First Amendment to the Draft SEIR CityView Plaza Office Project

May 2020

This First Amendment, together with the Draft Supplemental Environmental Impact Report (SEIR), constitute the Final SEIR for the CityView Plaza Office project.

Figure 1: Preservation Alternative A: Adjacent site acquisition (rendering by PAC*SJ)

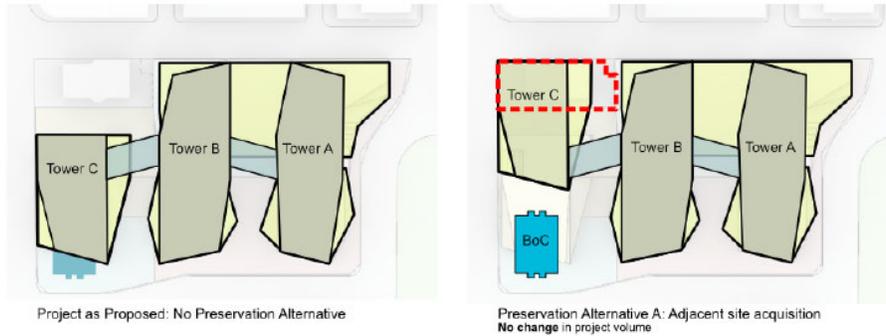
CEQA regulations require the exploration of alternative project locations that would avoid or substantially lessen adverse impacts to historic resources (Guideline §15126.6(f)(1)). While the project DSEIR does address the infeasibility of alternate locations for the entire 8.1-acre development site (DSEIR §7.4.1.1, p. 125), it fails to address the potential availability of an immediately adjacent development parcel (190 Park Center Plaza, APN #25941069) that could

accommodate a relatively minor adjustment to the project site plan and allow for the preservation of the Bank of California in situ without any negative impacts to the Cityview Plaza project goals (see Fig. 1, “Preservation Alternative A”). Therefore, the DSEIR incorrectly concludes that “the lack of available land to support the proposed project within the downtown” (p.125) renders alternative project locations infeasible.

Response G.3: Assumed acquisition of additional adjacent property is not a feasible alternative under CEQA. A project applicant cannot propose any land use change to a property they do not legally control, and the City Council cannot approve any private project proposal or alternative that considers the use of property not legally controlled by the project applicant.

Figure 2: Preservation Alternative B: Alternate Site Layout (rendering by PAC*SJ)

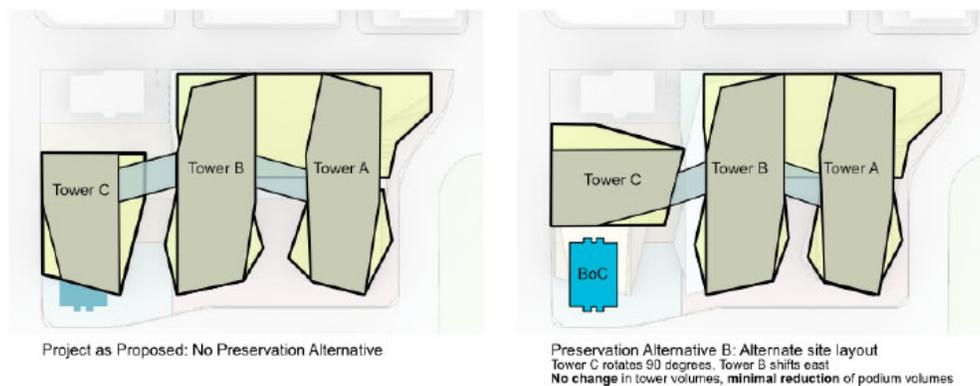
As presented, the combined footprints of the three proposed towers occupy only 4.4 acres of the 8.1-acre site, representing a 10.7 FAR on a site zoned for 30. This relative lack of density suggests ample opportunity for alternative site layouts to accommodate the preservation of the Bank of California in situ. Yet the DSEIR completely fails to explore feasible alternatives to the proposed building footprints or massing. PAC*SJ’s own initial analysis has identified at least one viable alternative site plan (Fig. 2, “Preservation Alternative B”) that appears to accommodate virtually all of the proposed project goals with only minor modifications to the siting and massing of the new development.

Figure 3: Preservation Alternative C: Reduced Tower C (rendering by PAC*SJ)

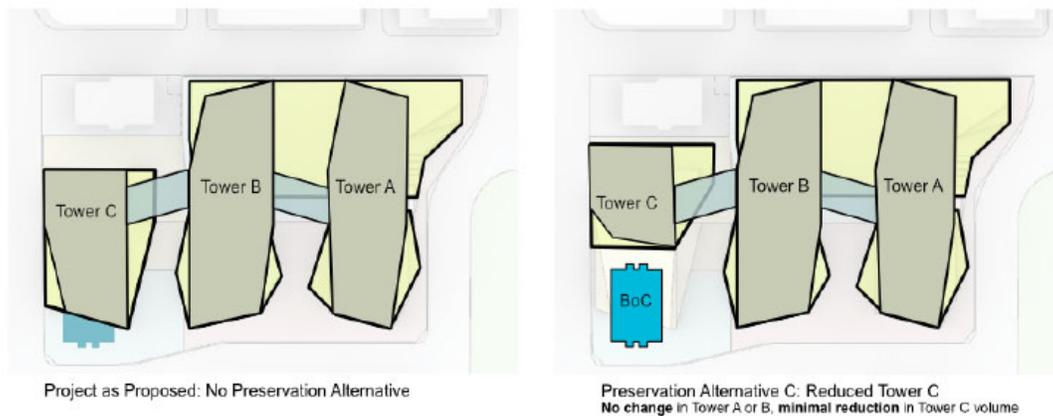
Comment G.4: CEQA Guidelines state that, in evaluating project alternatives, an EIR “shall include sufficient information about each alternative to allow meaningful evaluation, analysis, and comparison with the proposed project” (Guideline §15126.6(d)). In its cursory exploration of the preservation of the Bank of California (“Preservation Alternative 6” §7.4.1.6, p. 130), the DSEIR includes the unexplained and unsupported claim that the “preservation of the Sumitomo Bank [Bank of California] building would also require retention of the existing tower immediately north of the bank building (150 Almaden Boulevard). By retaining both buildings, only two of the three proposed towers could be constructed.” The DSEIR completely lacks sufficient evidence to support this conclusion, and does not demonstrate why a slightly reduced third tower cannot feasibly be constructed (see Fig. 3, “Preservation Alternative C”).

CEQA Guidelines further state that feasible project alternatives must be considered “even if these alternatives would impede to some degree the attainment of the project objectives, or would be more costly” §15126.6(b). Even the DSEIR’s questionable analysis of “Preservation Alternative 6” concedes that “the loss of approximately 605,958 to 1,211,916 square feet of office space would not, by itself, be inconsistent with the project objectives” (§7.4.1.6, p. 130). While we challenge the veracity of the lost square footage figures, we strongly concur that a majority of the proposed project goals can nevertheless be met without demolishing the Bank of California. Therefore the DSEIR’s ultimate rejection of Preservation Alternative 6 is flawed and unwarranted.

Figure 4.17-1, Existing Bicycle Facilities is **REVISED** as follows:

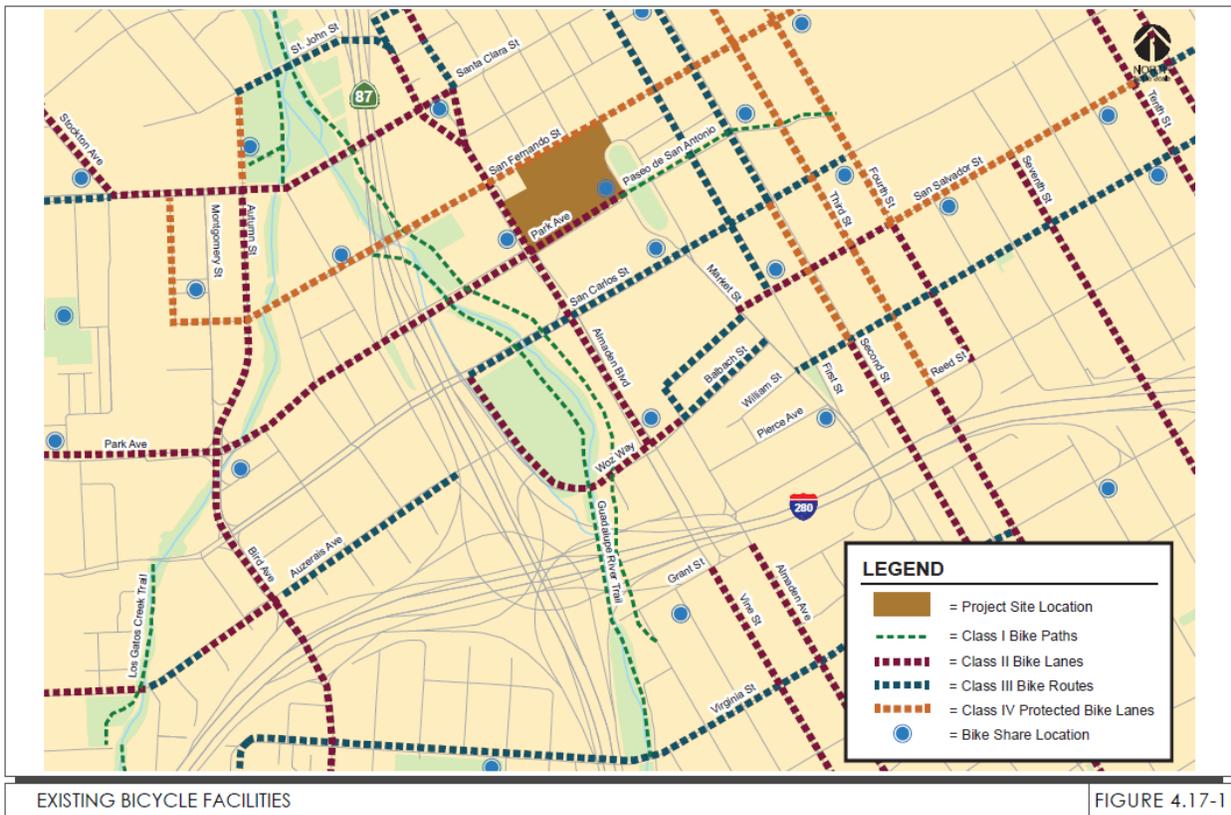
Comment D.17: Page 5, Figure 2: Class III bike route should be shown on St. John, from the Guadalupe River Trail to Autumn St.

Page 5, Figure 2: Class IV bike lane should be shown on Autumn St, from Santa Clara to St. John.

Page 5, Figure 2: Class IV bike lanes should be shown on Cahill St, from San Fernando St to Santa Clara St.

Page 5, Figure 2: Class IV bike lanes should be shown on San Fernando St, from Cahill to Almaden Blvd

Page 5, Figure 2: Almaden Ave and Vine St should be shown with Class II bike lanes.

Page 5, Figure 2: Bird Avenue has Class II bike lanes from San Carlos St to Coe Ave.

Page 5, Figure 2: William St is a Class III bike route from First St to McLaughlin Ave

Page 5, Figure 2: San Salvador St has Class IV bike lanes from 8th St to 10th St.

Page 5, Figure 2: Fourth St has Class IV bike lanes from San Salvador St to Santa Clara St

Page 5, Figure 2: There are bike share stations at Bird and Columbia, Park and Laurel Grove, Delmas and Virginia, San Salvador and 9th, William and 10th and Fountain Alley and 2nd.

Response D.17: Between the time the analysis is initiated and the Draft SEIR is circulated for public review, existing conditions can change. As a result, the commenter's assessment of bicycle facilities under current conditions is correct but differs from the conditions at the time the analysis was initiated which are described on the pages noted above in the comment. Refer to Section 5.0 Draft SEIR Text Revisions in this Final SEIR and Appendix C of this Final SEIR for the proposed amendments to Figure 2. These amendments do not change the findings of the Draft SEIR and recirculation of the Draft SEIR is not required. Refer also to Responses D.5 and D.9.

Figure 4.17-3, Existing Transit Facilities will be **REVISED**
as follows:

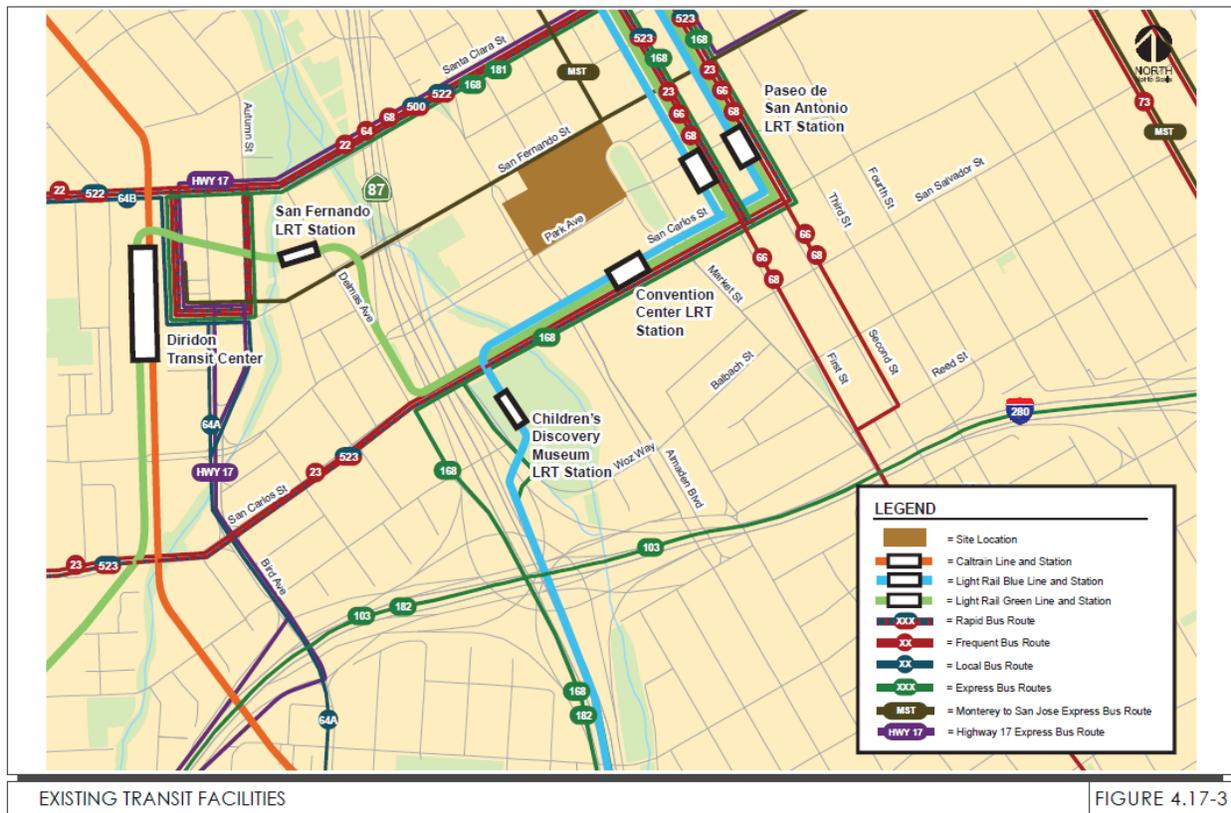
Comment D.18: Page 6: There are also existing transit services provided by Santa Cruz METRO and Monterey Salinas Transit.

Comment D.19: Page 8, Figure 4: VTA buses 72 and 73 turn off of San Fernando St at 6th St, not 1st and 2nd Streets.

Response D.18: Refer to Section 5.0 Draft SEIR Text Revisions in this Final SEIR and Appendix C of this Final SEIR for the proposed text amendment. This amendment does not change the findings of the Draft SEIR and recirculation of the Draft SEIR is not required.
